MEETING SUMMARY
BRUNSWICK HYDROELECTRIC PROJECT

FERC NO. 2284

DOWNSTREAM FISH PASSAGE ALTERNATIVES MEETING

January 27, 2026

Alternative D4B - Single Fish Friendly Runner Replacement with Inclined Rack

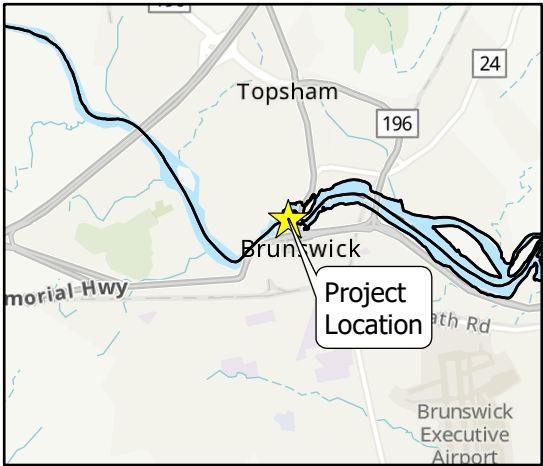
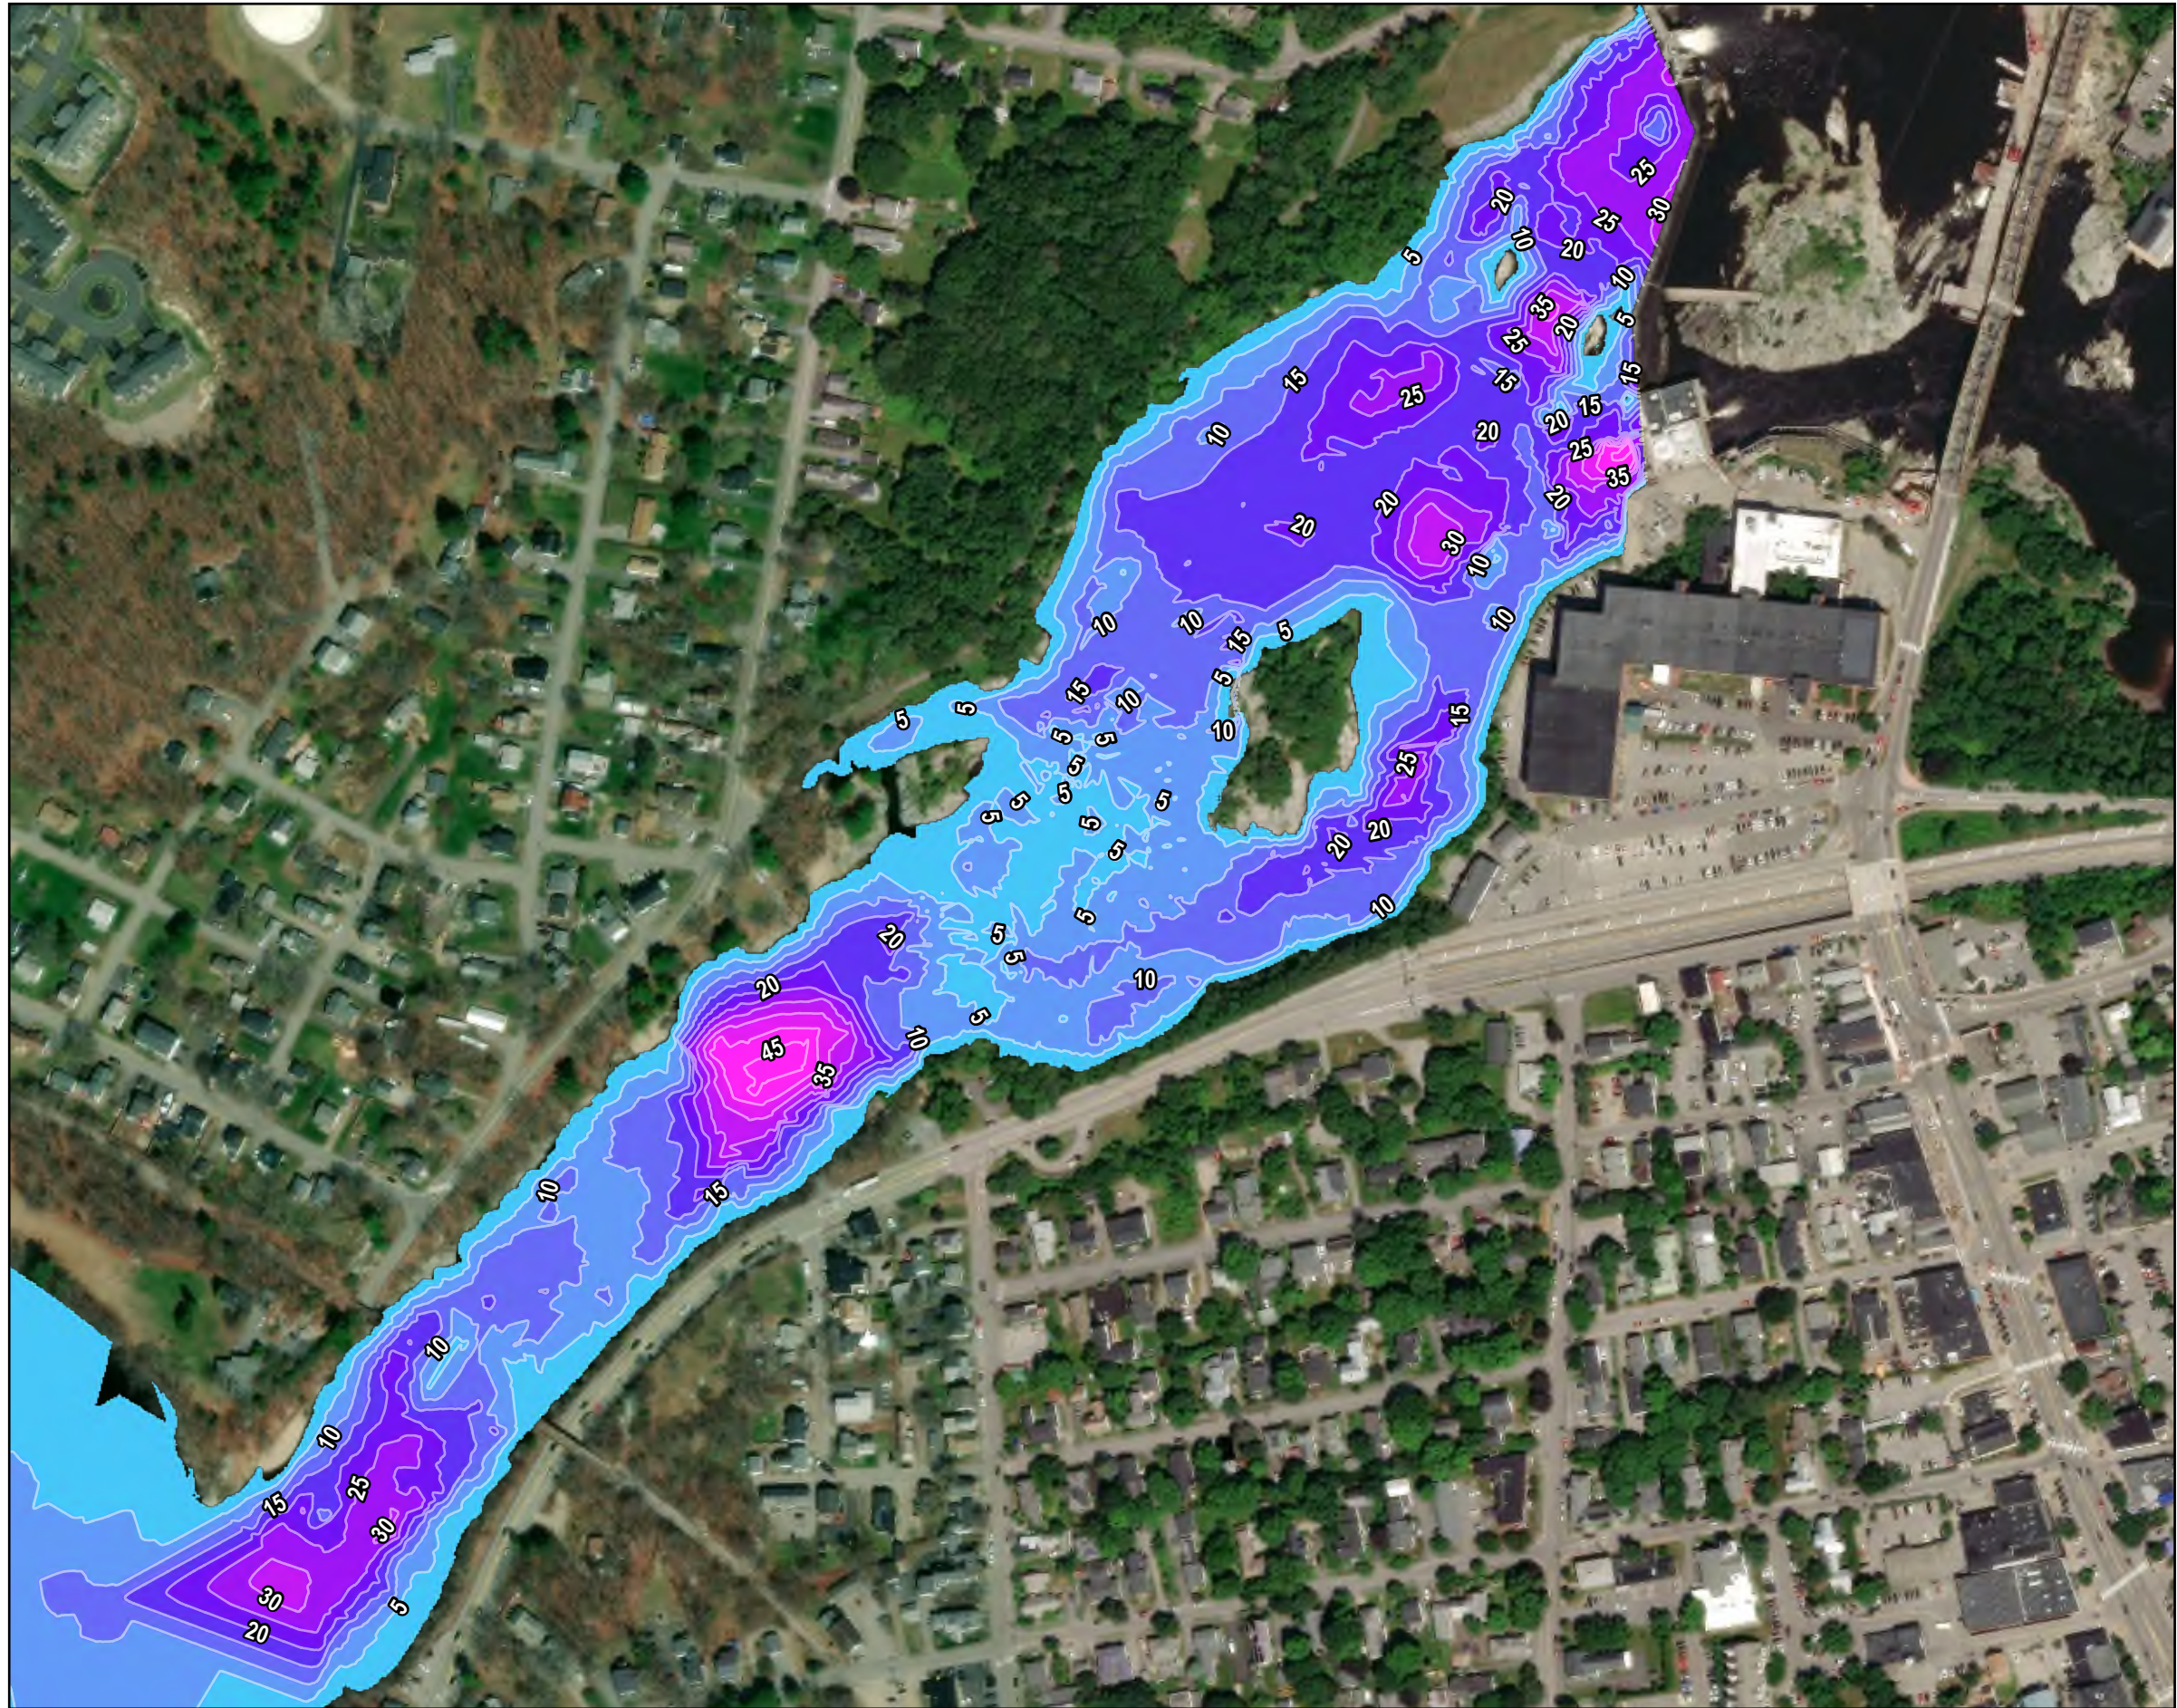
Patrick Dockens asked if the inclined rack was placed on Units 2 and 3, rather than Unit 1 for cost reasons and ease of construction. Lucas Stiles stated more flow goes through Unit 1 so there would be more benefit from the Natel turbine runner, and this configuration is likely the lower cost alternative.

Casey Clark requested that a flow duration analysis of the site be conducted to understand how often the capacity of all three units is exceeded during the upstream and downstream passage season, and to understand any type of unit prioritization that is currently occurring. Casey said there is some unit prioritization occurring for upstream passage and it would be helpful to see how this alternative looked under those different operational scenarios. Casey said it would also be helpful to understand the service life of the current units to see how it aligns with the overall cost for the licensee during the license term.

Casey Clark commented that for the Natel turbine runner options there would be times when spill is occurring and that would provide a downstream passage route, and that an evaluation of the spillway for safe passage should be conducted.

Patrick Dockens asked about the training wall river left with this alternative and whether there is a chance fish get stuck in that area. Lucas Stiles stated there is some possibility of delay, but theoretically fish should be able to find the intended passage route through Unit 1.
